TOWN OF WELLS, MAINE
PLANNING BOARD

Meeting Agenda
Monday, March 9, 2026, 7:00 PM
Littlefield Meeting Room, Town Hall
208 Sanford Road

Sheet No.: C1.1

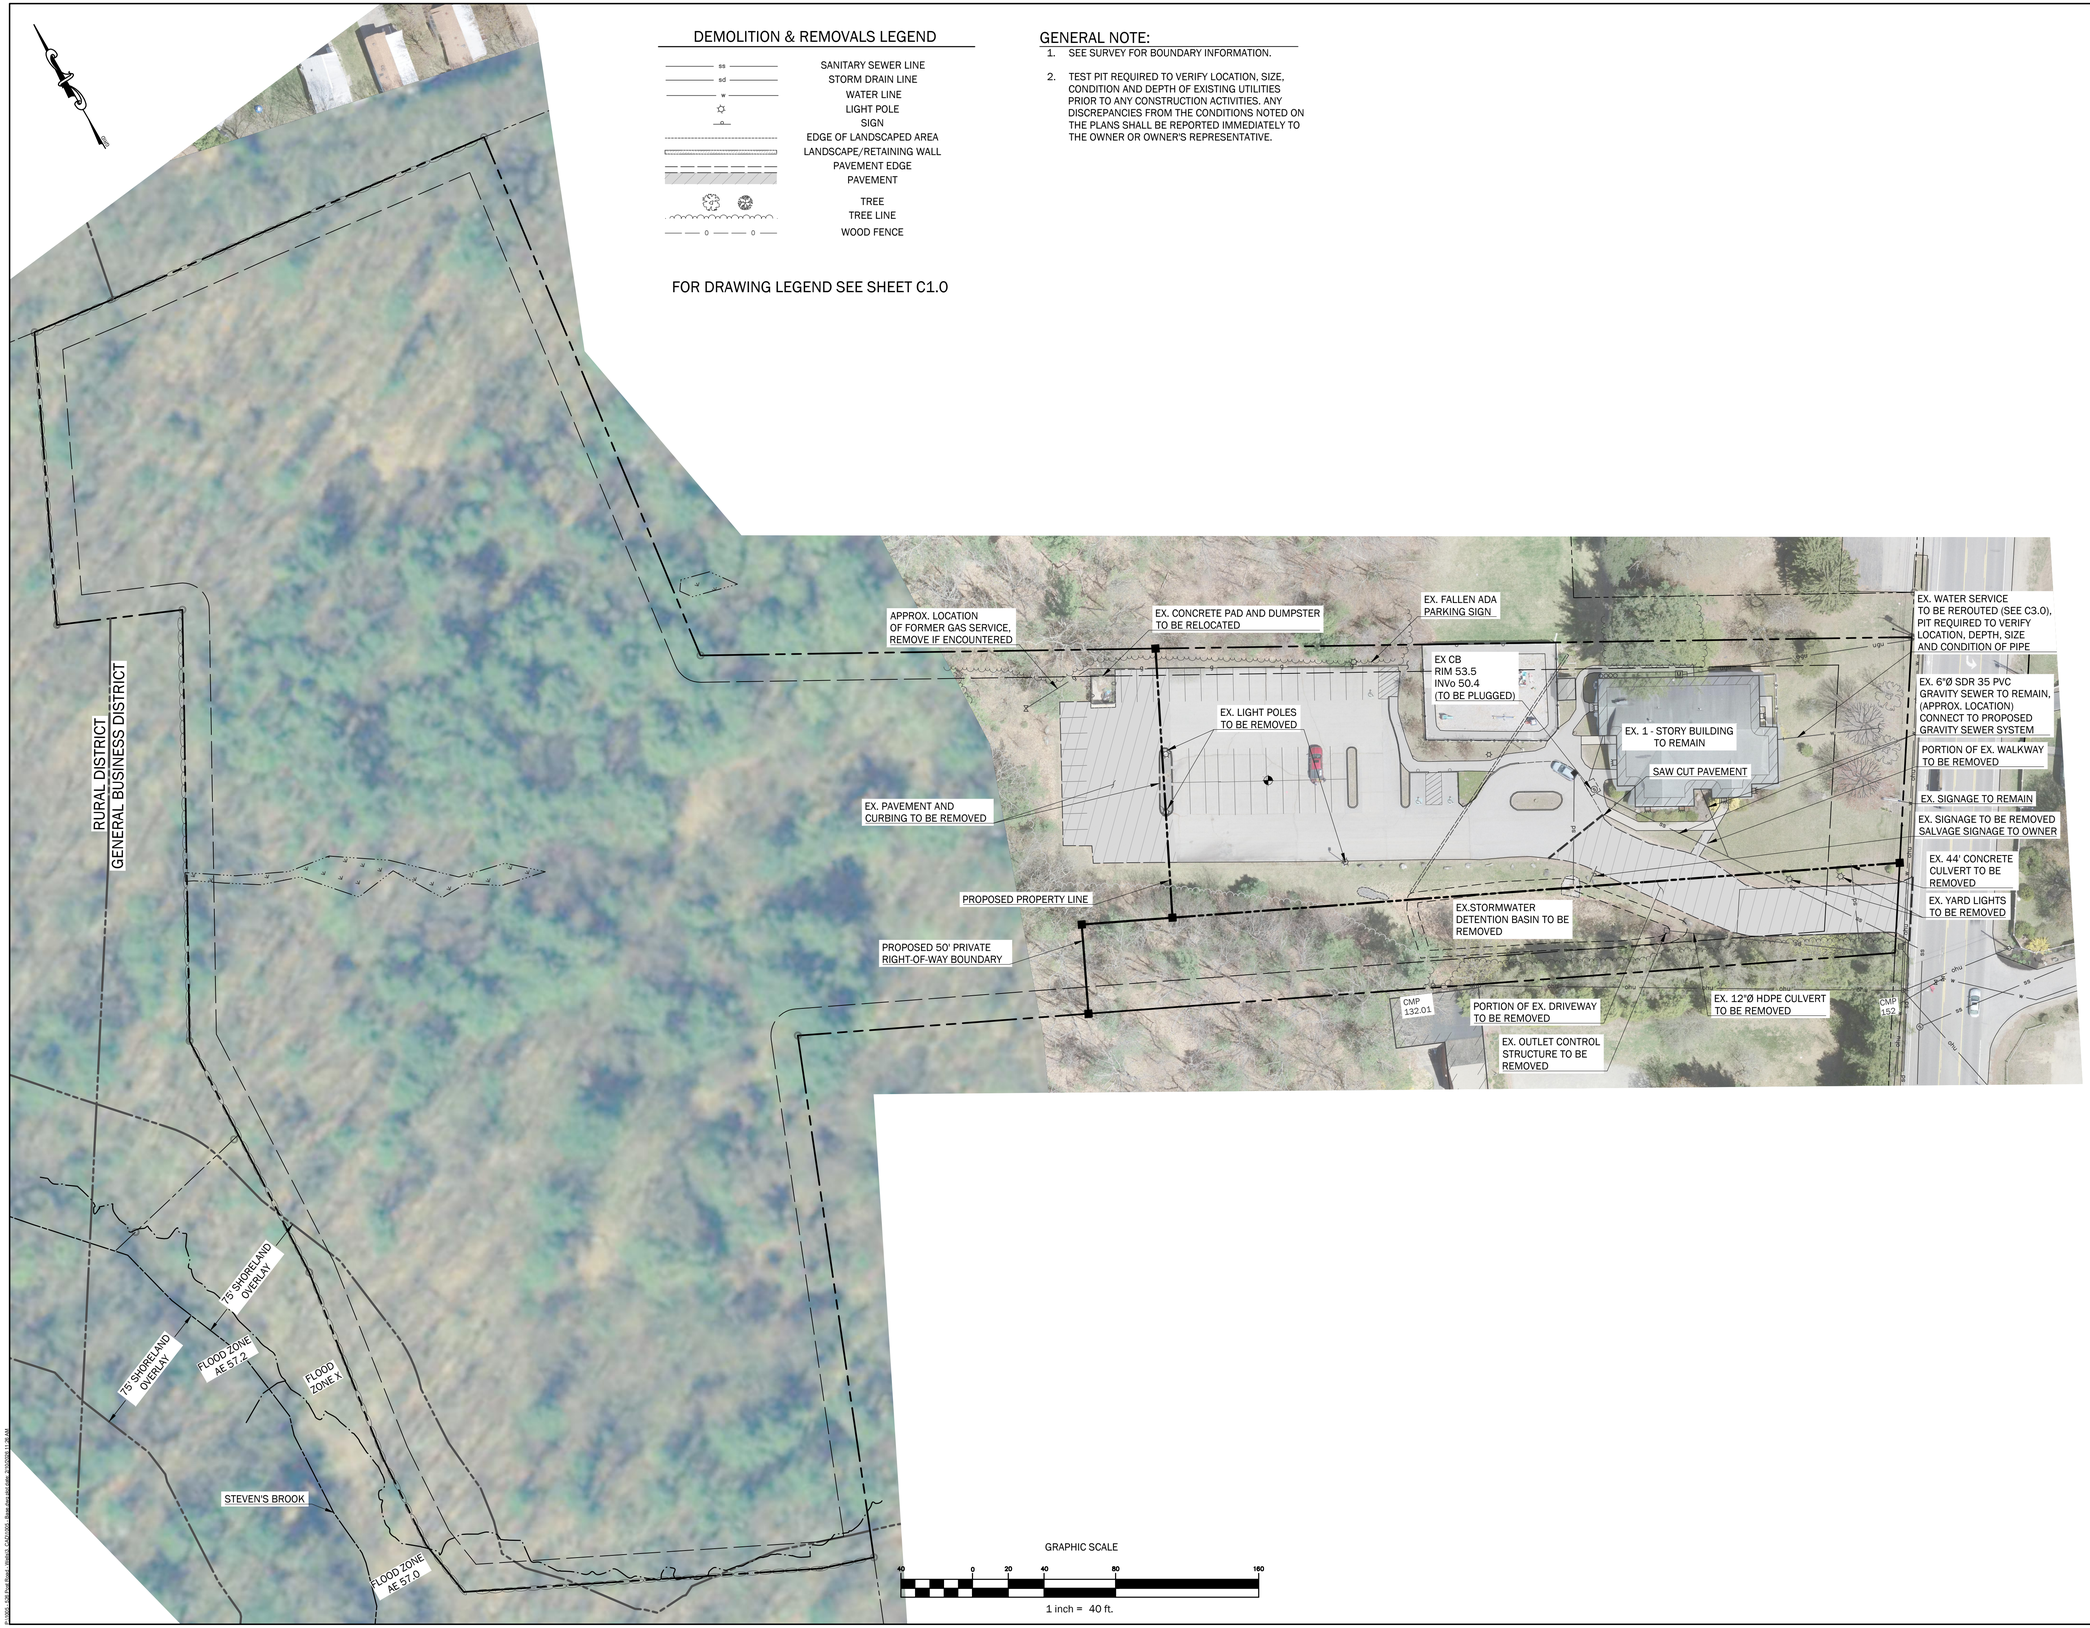
A.(4)	All existing and proposed setback dimensions	15' lot line setbacks shown. 40' lot line setback from Route One shown. **25' lot line setback from Arundel Lane ROW proposed, Per 145-35.O this 25' setback can be reduced to 15'.**	Y	C2.0	The setback off of the proposed lot line abutting the Arundel Lane R.O.W. has been reduced to 15' in the updated design plans included herein.

ITEM NUMBER	DESCRIPTION	STAFF COMMENT 1/23/2026	COMMENT ADDRESSED	DRAWING / SHEET NUMBER	COMMENT RESPONSE 2/10/2026
A.(14)	The lot lines of all lots abutting the proposed development, including those lots across the street, together with the names on file in the Town offices as of the date of the application	All abutters are identified, except proposed Map 127, Lot 10-1	Y	C2.0	Proposed lot 10-1 has been identified on C2.0 - Site Plan.

Sheet No.: C2.0

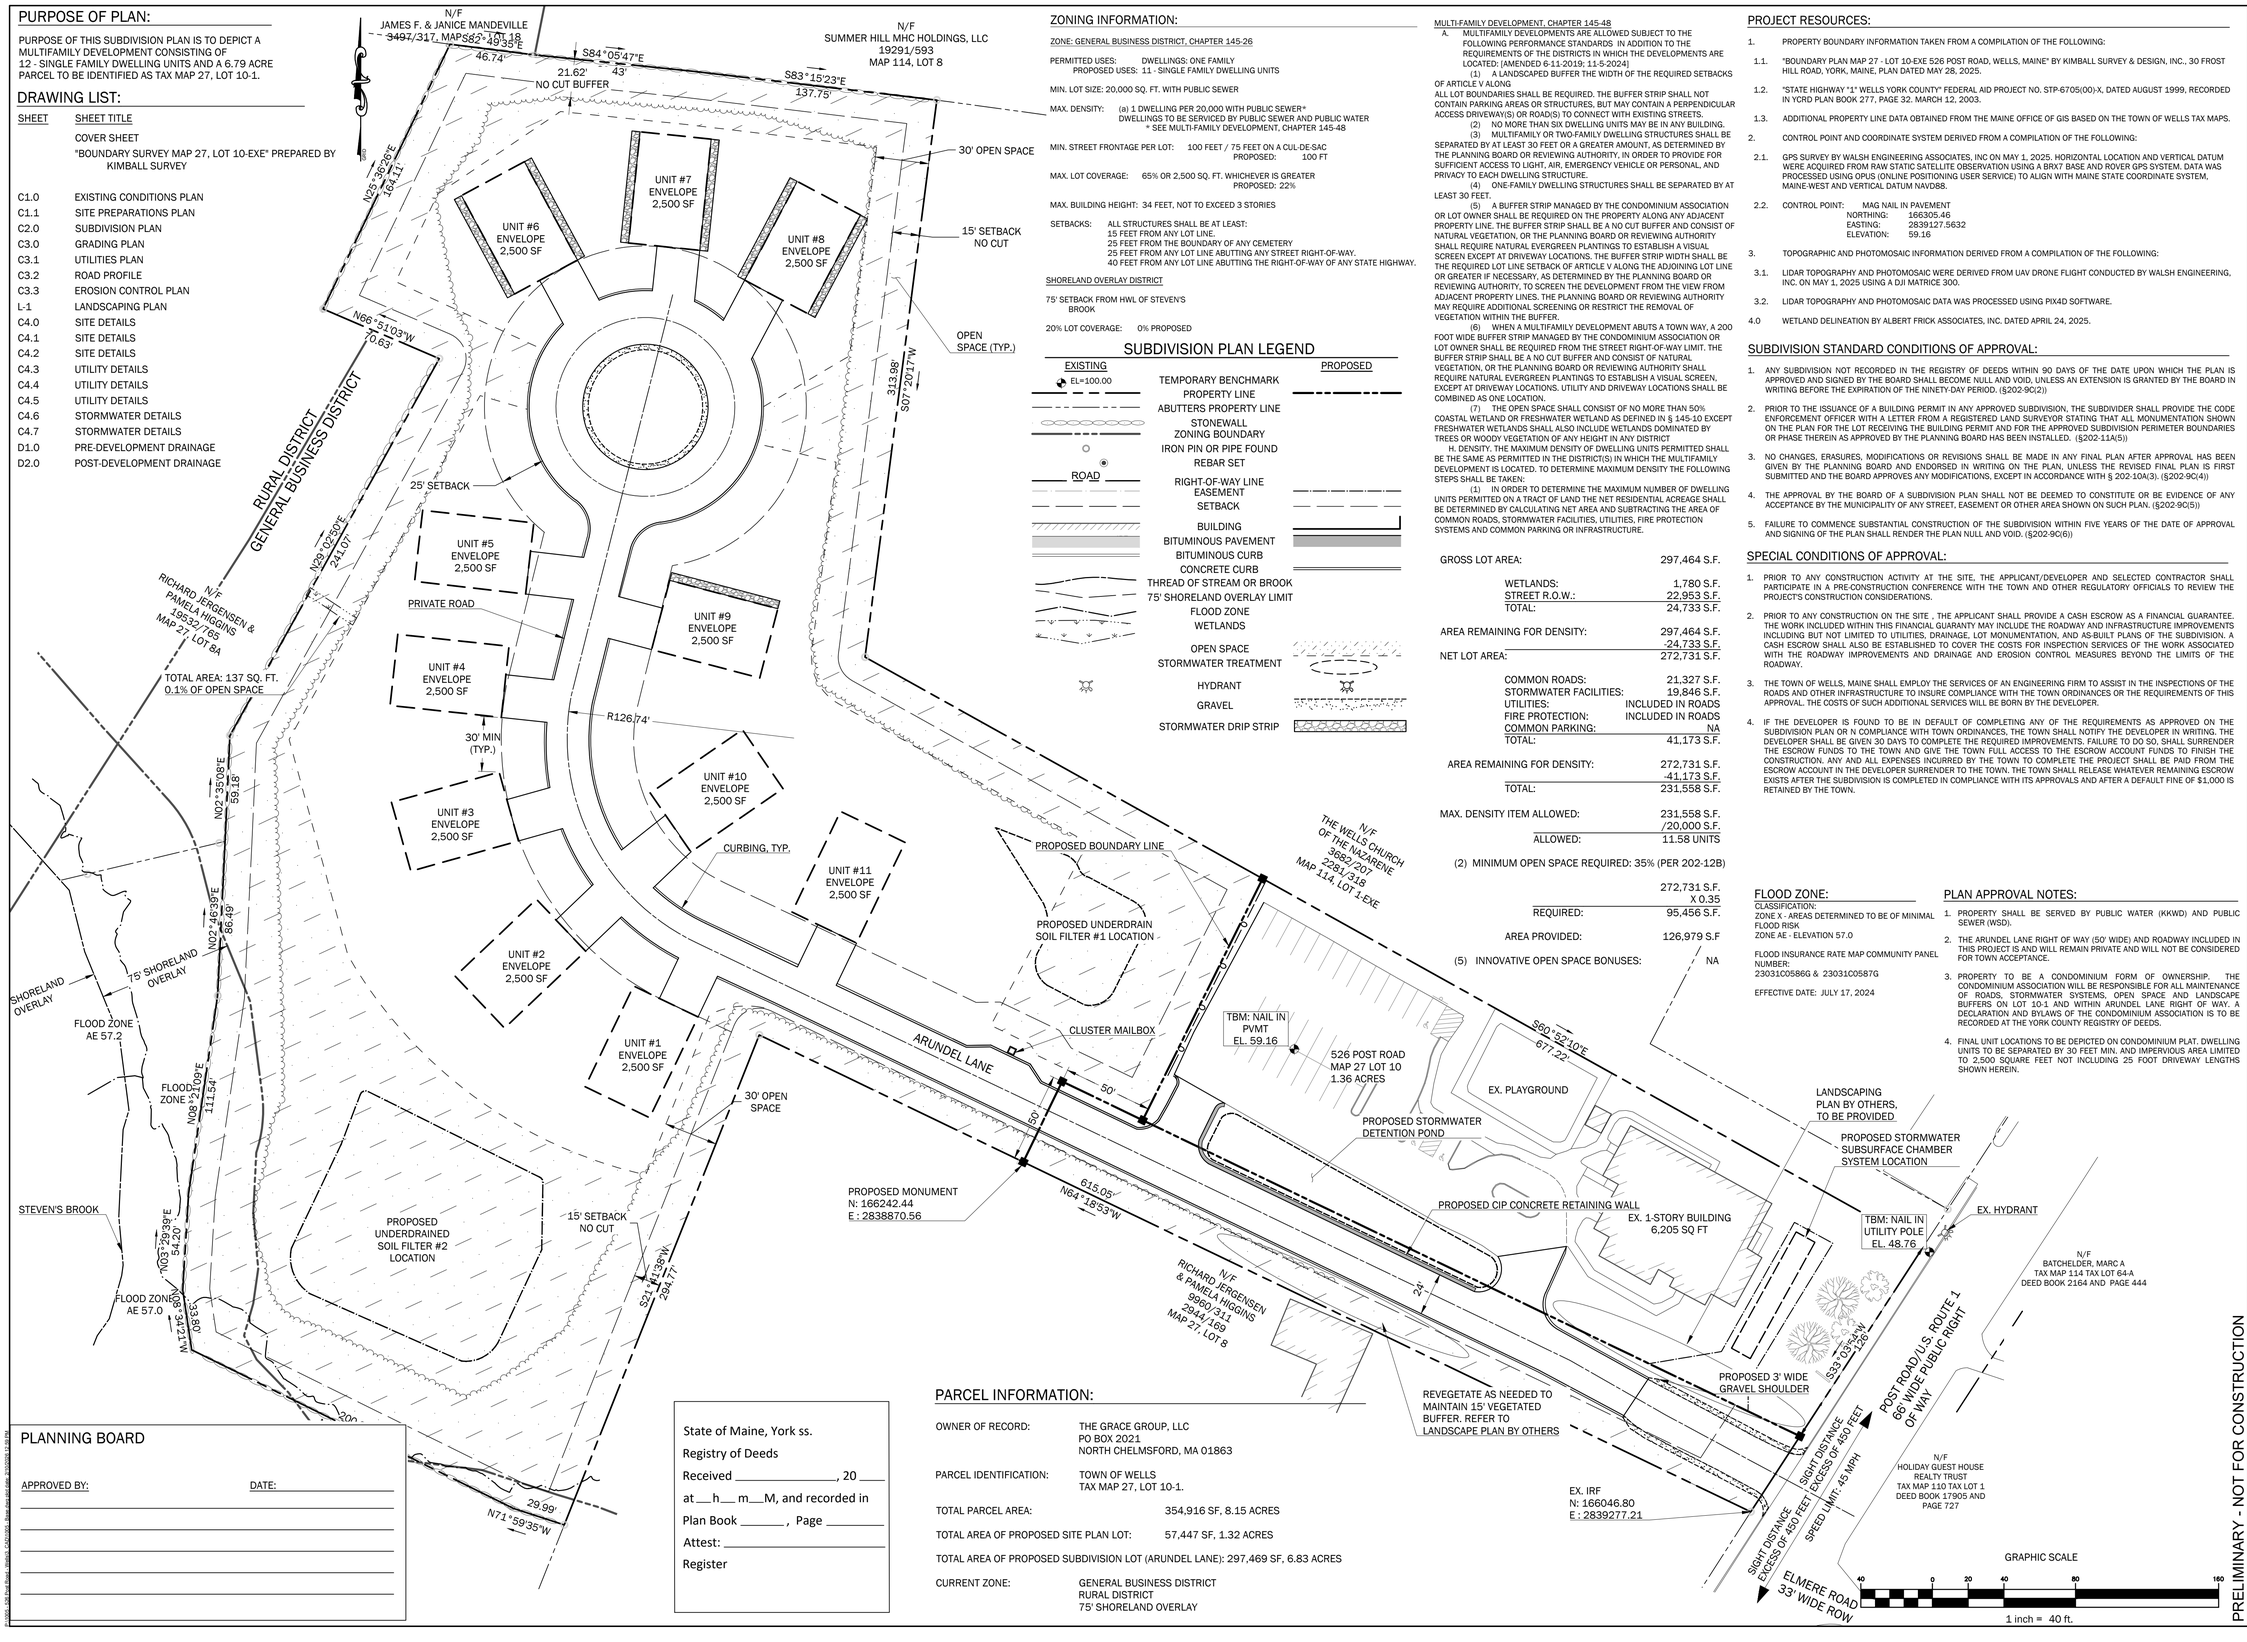
xiv. Are the 2,500 square feet boxes on the plan building envelopes or exact building footprints? Will decks, porches, patios, generators, sheds, fire pits, HVAC units, etc. be allowed for each unit? If so, lot coverage to facture. The 2,500-square-foot boxes shown on the plans represent approximate building envelopes that cap the building, deck, porch, generator, HVAC, and other impervious features at 2,500 square feet per unit. Lot-coverage calculations are based on this maximum; actual as-built coverage may be less but will not exceed the 2,500-square-foot allowance shown on plan C2.0.

F.(6).a. [3]	Twenty-five feet from any lot line abutting any street right-of-way.	**Parcel does abut the Arundel Lane ROW. 25' setback to be identified.**	Y	C2.0	Proposed 25' setback off of Arundel Lane ROW has been added.
145-48	**PERFORMANCE STANDARDS - MULTIFAMILY DEVELOPMENTS**				
A.(1)	A landscaped buffer the width of the required setbacks of Article V along all lot boundaries shall be required. The buffer strip shall not contain parking areas or structures, but may contain a perpendicular access driveway(s) or road(s) to connect with existing streets	15' wide landscaped buffer along all lot lines noted. **Label corrections needed.** Arundel Lane roadway serving the multifamily development crosses the buffer required from the street ROW.	Y	All Sheets	Labels for the proposed 15' landscaped buffers for the multifamily development have been updated accordingly on all sheets.
A.(4)	One-family dwelling structures shall be separated by at least 30 feet.	**Single family dwellings shall be separated by a minimum of 30 feet. Measurements between the units on the plan appear to be 28 or 29', not 30'.** **Plan provided is not to scale.**	Y	All Sheets	Confirmation that all building envelopes are separated by 30 feet. Plans have been printed with correct margins to provide accurate scale.
